Critique of NAAQS Exceedance Evaluations
Submitted to Louisiana Department of Environmental Quality
February 16, 2026

Conducted by:
Steven Klafka, P.E., BCEE
Wingra Engineering
Madison, Wisconsin

Wingra Engineering was hired by Earthjustice to assess the air modeling impact analyses submitted to the Louisiana Department of Environmental Quality (LDEQ) by nine facilities which had been issued air quality permits under the Prevention of Significant Deterioration (PSD) regulations during a time period from 2014 to 2024. To obtain their PSD permits, the facilities had conducted dispersion modeling analyses to verify compliance with air quality standards. These analyses had predicted exceedances of the national ambient air quality standards (NAAQS).

Figure 9 – Plaquemines LNG Receptor Grid Evaluating Compliance with 24-hour Average NAAQS for PM_{2.5}

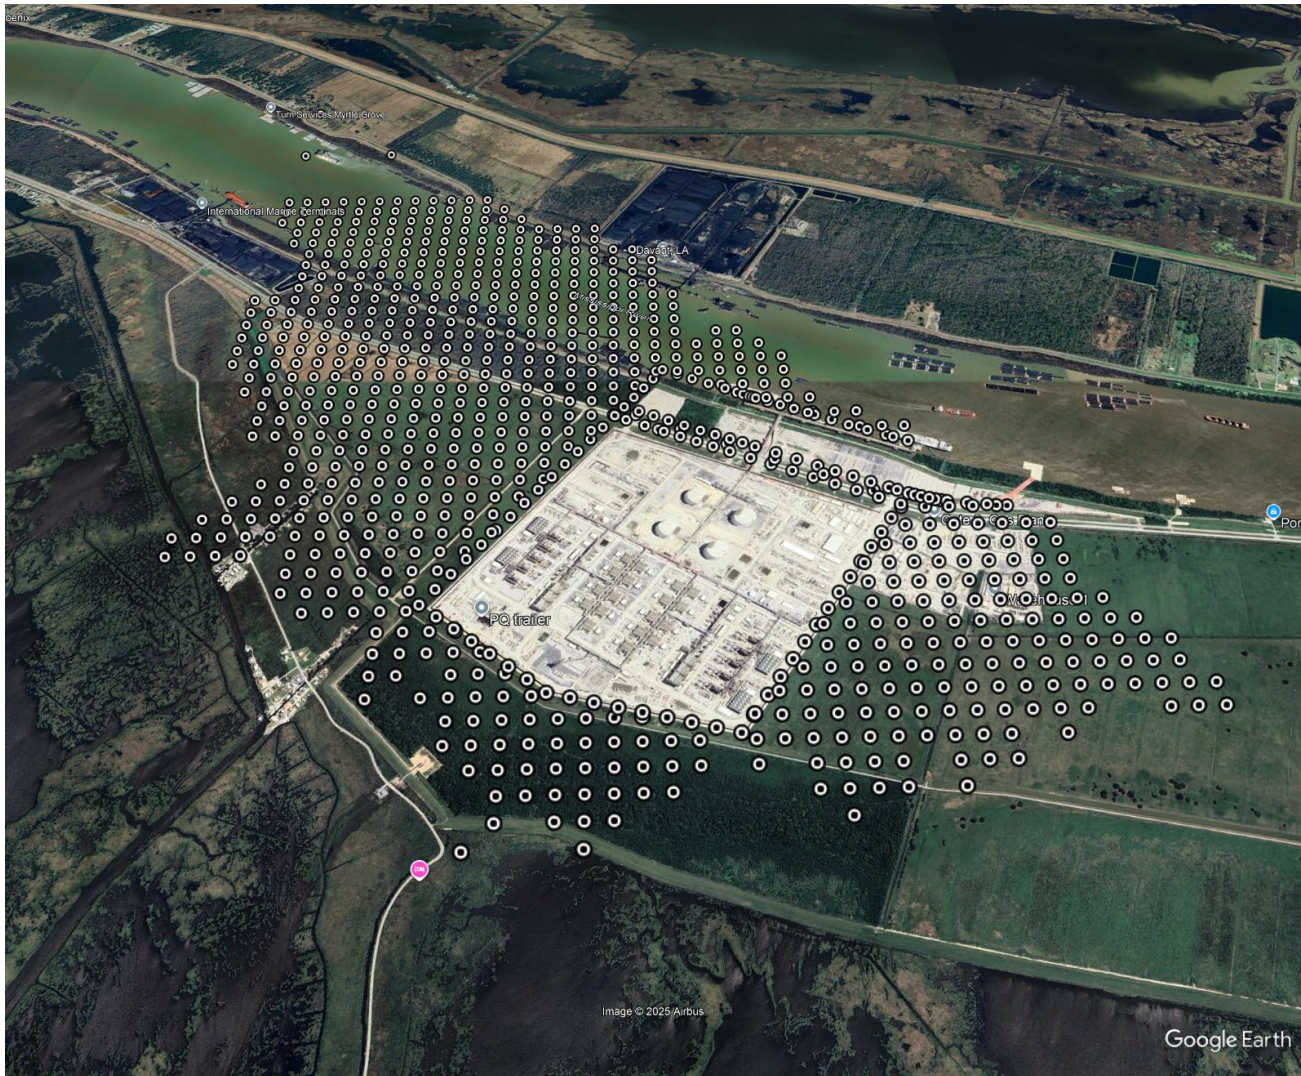
This shows the receptor grid is no further than 3 km from the facility. Figure 9 provided with this report displays the Google Earth image of the receptor grid used to determine compliance with the 24-hour NAAQS for PM_{2.5}

Unlike NO₂ and SO₂, no AERMOD modeling files were provided for PM_{2.5} so it was not possible to review the location of the receptors and off-site sources used for the exceedance evaluation. The provided Google Earth file did provide the location of the off-site sources.

The original modeling files for the 2019 PSD permit application were not provided so it is not known how large of a receptor grid was originally used to identify exceedances of the 24-hour NAAQS for PM_{2.5}. I did prepare a previous report evaluating the modeling analysis for the 2020 permit application for a modification of the Plaquemines LNG facility, titled: *Plaquemines LNG, Plaquemines Parish, Louisiana, Evaluation of Compliance with the 1-hour Average NAAQS for NO₂, May 25, 2022*. This report concluded that the analysis used for the 2020 permit application for a modification of the facility did not extend to 50 km so was not adequate to identify all exceedances around the off-site sources. This suggests the 2019 PSD permit modeling analysis evaluated in this report also did not extend the receptor grid to 50 km. To identify all possible exceedances within the 50 km acceptable modeling domain for AERMOD, the modeling for NAAQS compliance needs to be repeated using a grid that extends out to 50 km.

Since the modeling analyses was conducted in 2019, *i.e.* prior to the reduction in the annual average NAAQS and SIL for PM_{2.5}, the analyses do not evaluate compliance with current SIL and annual average NAAQS for PM_{2.5}.

Figure 10 – Plaquemines LNG Receptor Grid & Sources Evaluating Compliance with 1-hour average NAAQS for NO₂

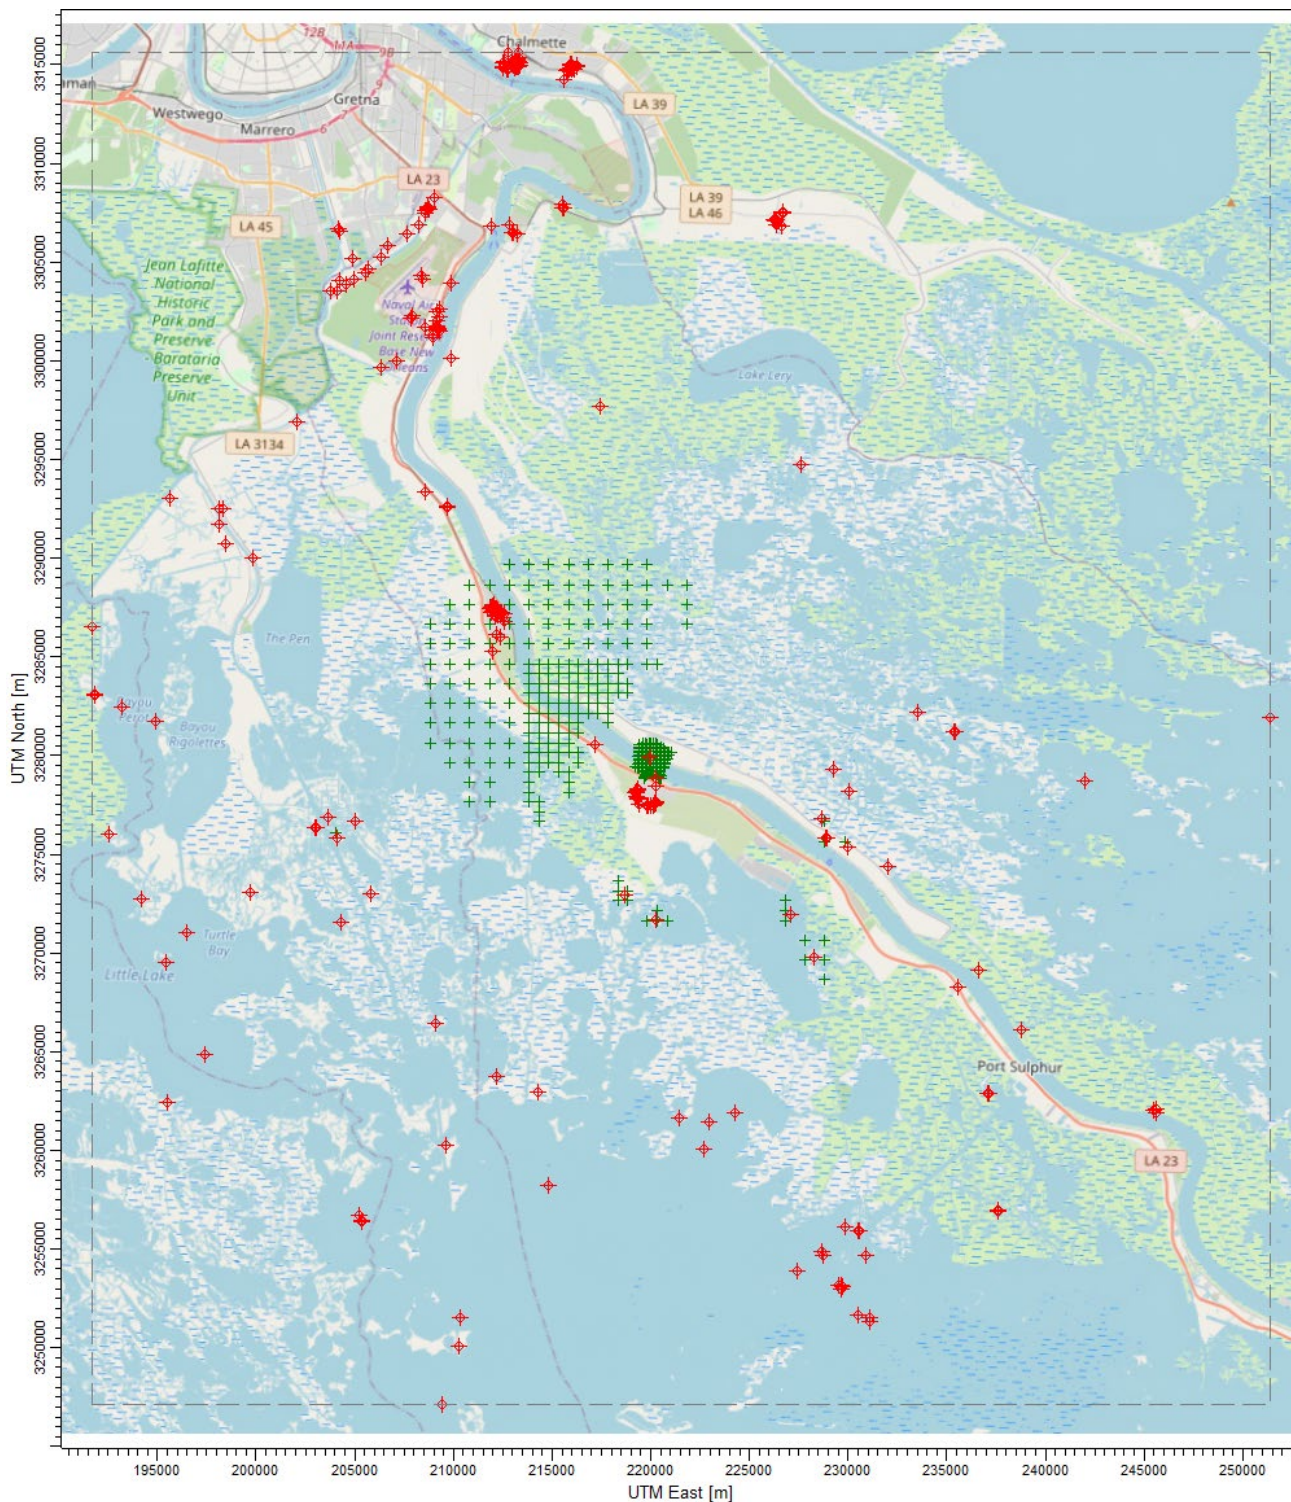
Figure 10 provided with this report displays the receptor grid and sources used to determine compliance with the 1-hour average NAAQS for NO₂. The receptors are green crosses and the sources are red circles with cross hatching.

The original modeling files for the 2019 PSD permit application were not provided so it is not known how large of a receptor grid was originally used to identify exceedances of the 1-hour average NAAQS for NO₂. I did prepare a previous report evaluating the modeling analysis for the 2020 permit application for a modification of the Plaquemines LNG facility. This was prepared for the Sierra Club and submitted to LDEQ, and entitled: *Plaquemines LNG, Plaquemines Parish, Louisiana, Evaluation of Compliance with the 1-hour average NAAQS for NO₂, May 25, 2022*. This report concluded that the analysis used for the 2020 permit application for a modification of the facility did not extend to 50 km so was not adequate to identify all NO₂ exceedances around the off-site sources. This suggests the 2019 PSD permit modeling analysis evaluated in this report also did not extend the receptor grid to 50 km. To identify all possible exceedances within the 50 km acceptable modeling domain for AERMOD, the modeling for NAAQS compliance needs to be repeated using a receptor grid that extends out to 50 km. This larger receptor grid will estimate

concentrations around many of the off-site sources, like those in the New Orleans metropolitan area located to the northwest. Currently there are no receptors or concentrations predicted near these off-site sources so it is not known if exceedances of the NAAQS will occur.

Figure 11 - Plaquemines LNG Receptor Grid & Sources Evaluating Compliance with 1-hour Average NAAQS for SO₂

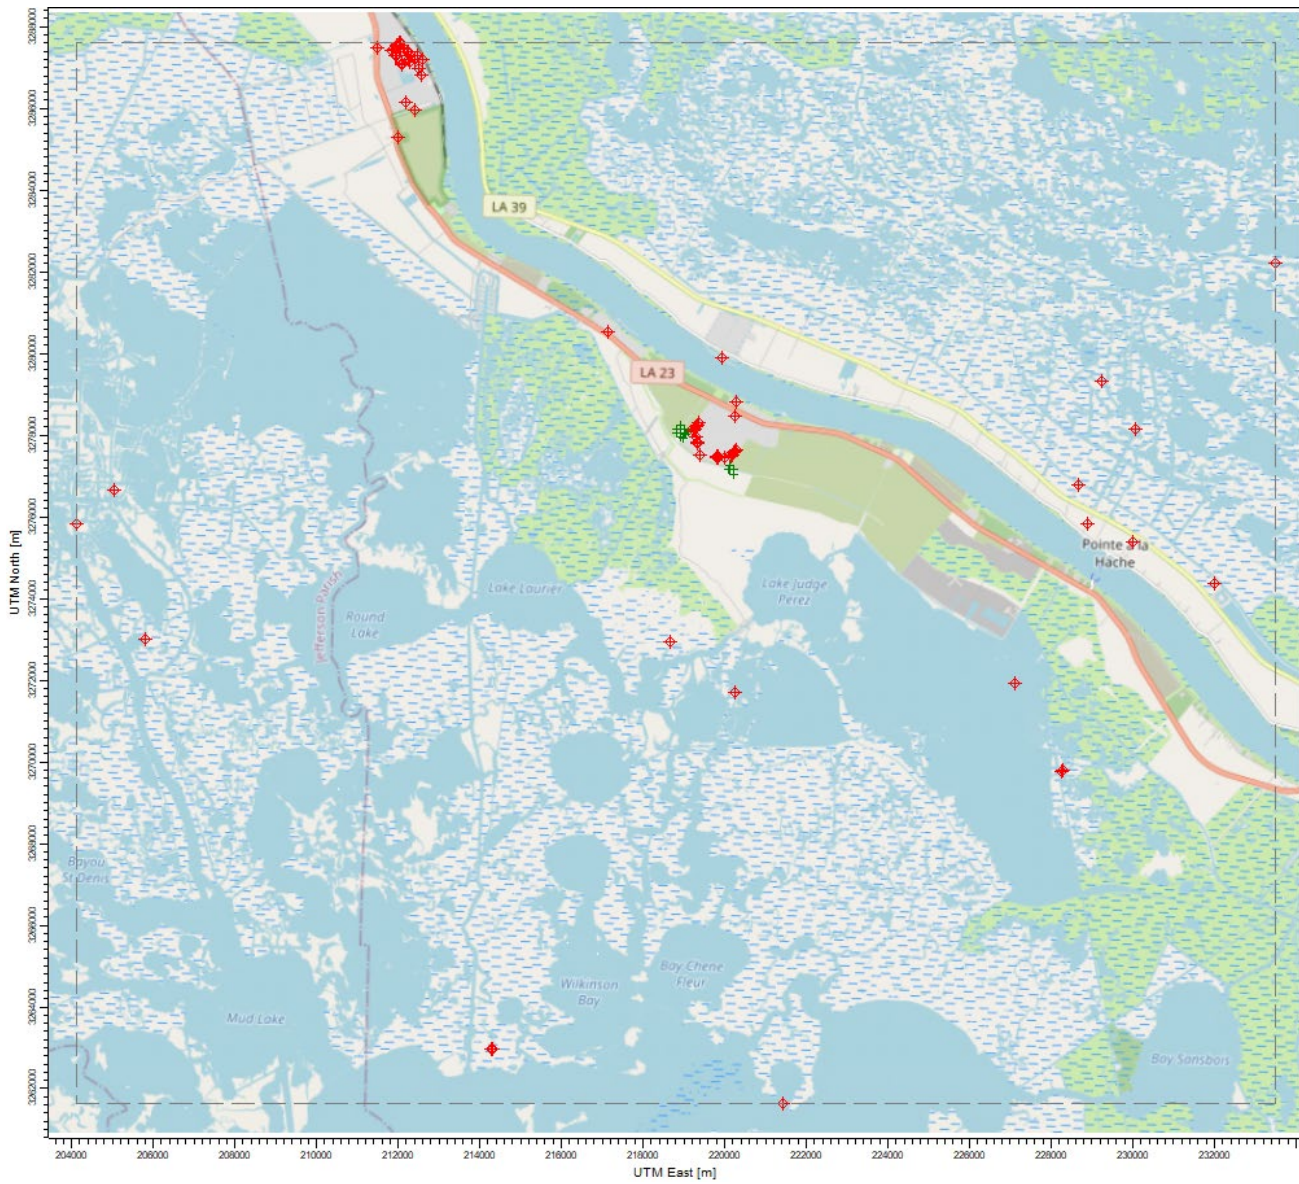
Figure 11 provided with this report displays the receptor grid and sources used to determine compliance with the 1-hour average NAAQS for SO₂. The receptors are green crosses and the sources are red circles with cross hatching.

Based on a review of this SO₂ modeling file submitted by Plaquemines LNG, the 17 receptors evaluated by Plaquemines LNG only extended 0.5 km from facility. The off-site sources were located as far as 16 km from the facility, so the receptors were not sufficient to determine if there were NAAQS exceedances near the off-site sources.

The original modeling files for the 2019 PSD permit application were not provided, so it is not known how large of a receptor grid was originally used to identify exceedances of the 1-hour average NAAQS for SO₂. I did prepare a previous report evaluating the modeling analysis for the 2020 permit application for a modification of the Plaquemines LNG facility. This was prepared for the Sierra Club and submitted to LDEQ, and entitled: *Plaquemines LNG, Plaquemines Parish, Louisiana, Evaluation of Compliance with the 1-hour average NAAQS for NO₂, May 25, 2022*. This report concluded that the analysis used for the 2020 permit application for a modification of the facility did not extend to 50 km so was not adequate to identify all exceedances around the off-site sources. This suggests the 2019 PSD permit modeling analysis evaluated in this report also did not extend the receptor grid to 50 km. To identify all possible exceedances within the 50 km acceptable modeling domain for AERMOD, the modeling for NAAQS compliance needs to be repeated using a receptor grid that extends out to 50 km.

Figure 14 - Shintech Receptors and Sources Evaluating Compliance with 24-hour NAAQS for PM_{2.5}

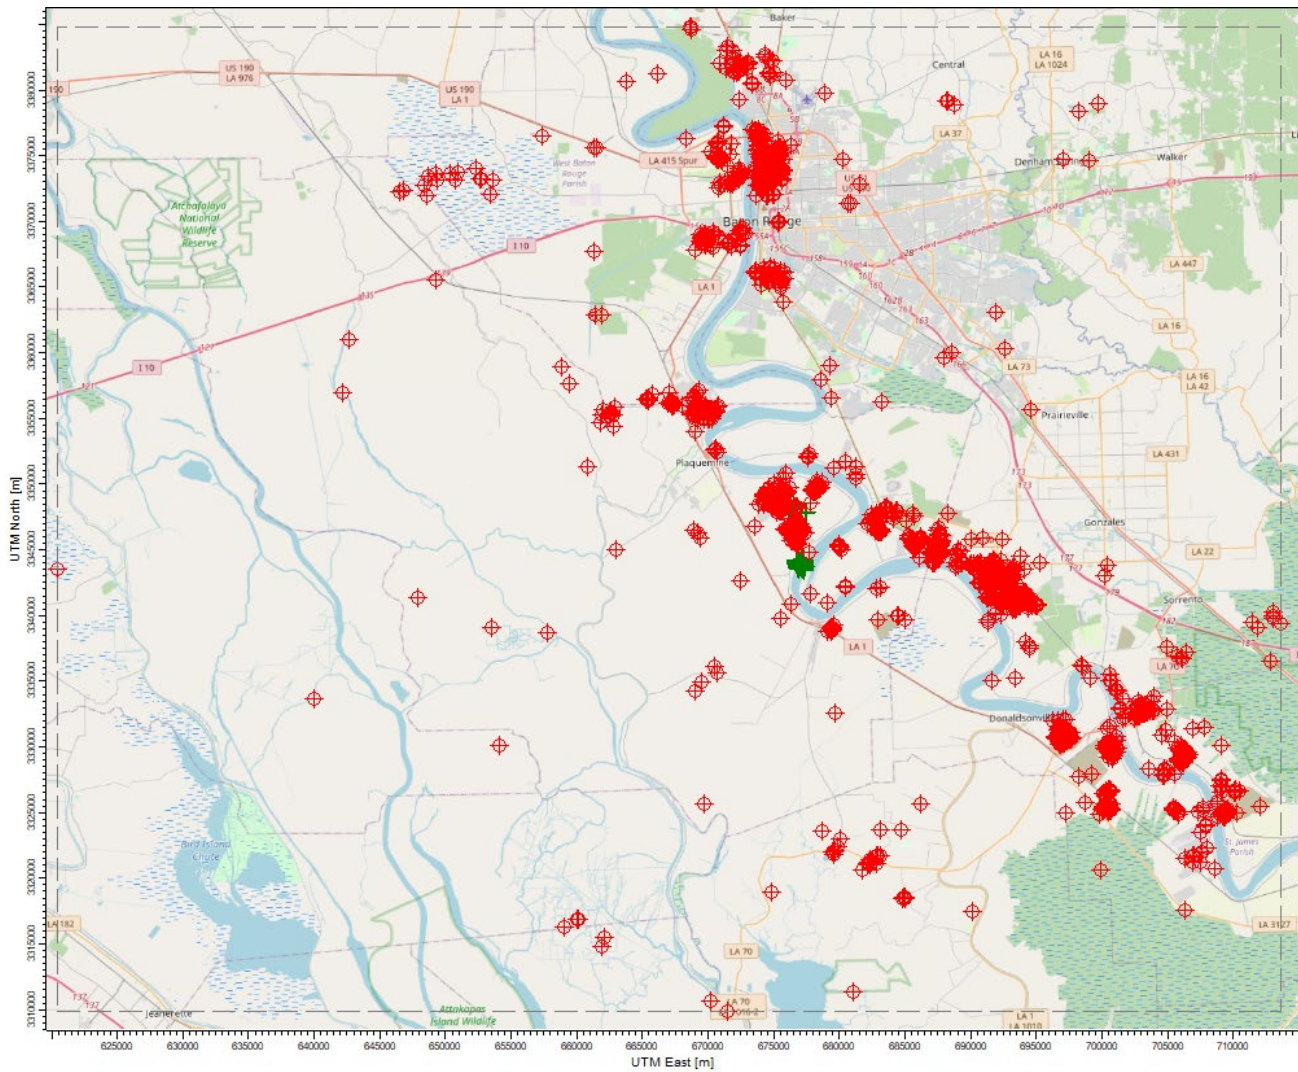
Figure 14 provided with this report displays the receptor grid and sources used to determine compliance with the 24-hour NAAQS for PM_{2.5}. The receptors are green crosses, and the sources are red circles with cross hatching.

There were only 70 receptors extending to only 2 km from the facility. There were 4,042 total sources out to a distance of 50 km from the facility. Since the receptor grid did not extend beyond 2 km, it was not capable of determining if there were NAAQS exceedances around the off-site sources.

Figure 15 - WPEC Receptors and Sources Evaluating Compliance with 1-hour Average NAAQS for NO₂

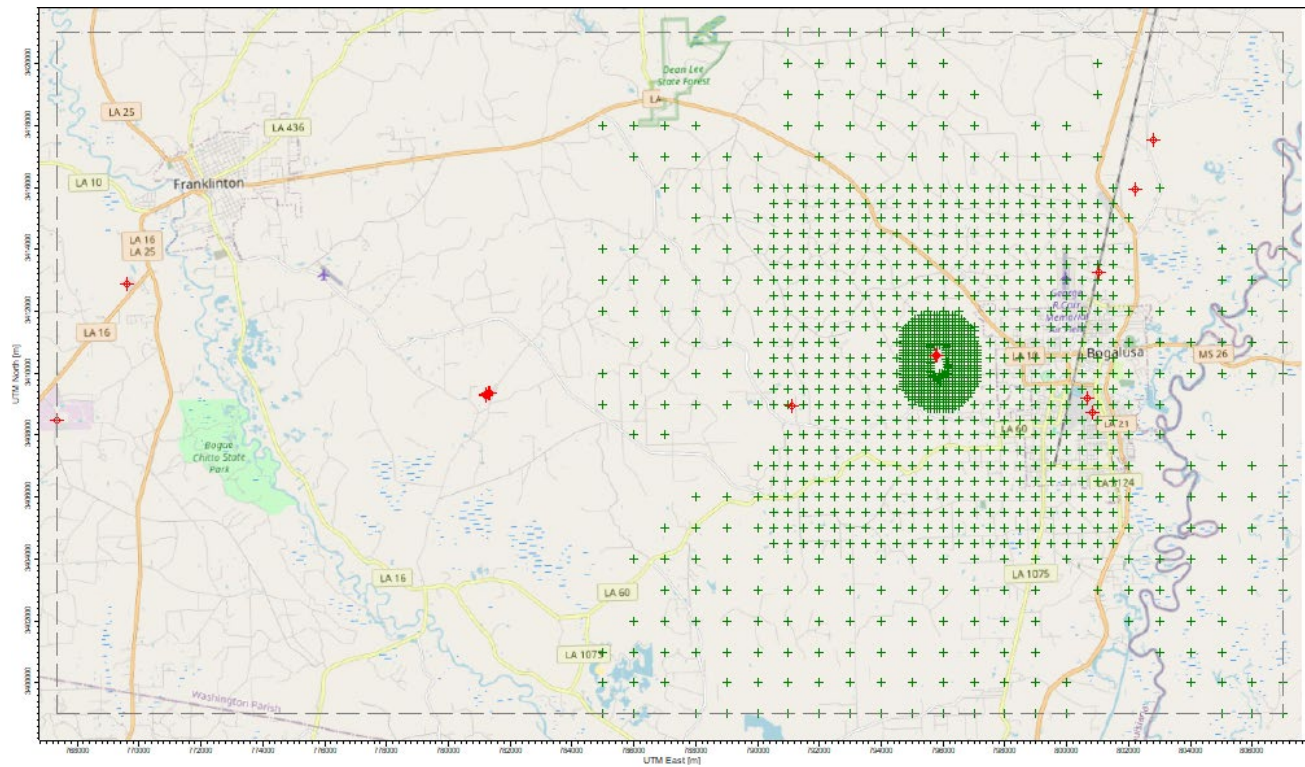
Figure 15 provided with this report displays the receptor grid and sources used to determine compliance with the 1-hour average NAAQS for NO₂ for the commissioning scenario. A figure for the routine scenario would look similar. The receptors are green crosses and the sources are red circles with cross hatching.

There were 1,437 receptors extending to 15 km from the facility. There were 40 total sources out to a distance of 28 km from the facility. At the outside of the grid, receptors were spaced 1 km apart. Since the receptor grid did not extend beyond 15 km, it was not capable of determining if there were NAAQS exceedances around the off-site sources.

As requested by LDEQ, figures were provided identifying receptors with predicted exceedances in the August 21, 2023 submittal. In the files LDEQ provided, title pages were provided but there were no figures. As requested by LDEQ, spreadsheets were provided which showed the culpability of specific off-site sources to predicted exceedances. The culpability was provided only for the receptors evaluated in the model analysis. These receptors were too few and too far apart to identify all potential exceedances of the NAAQS around the off-site sources.
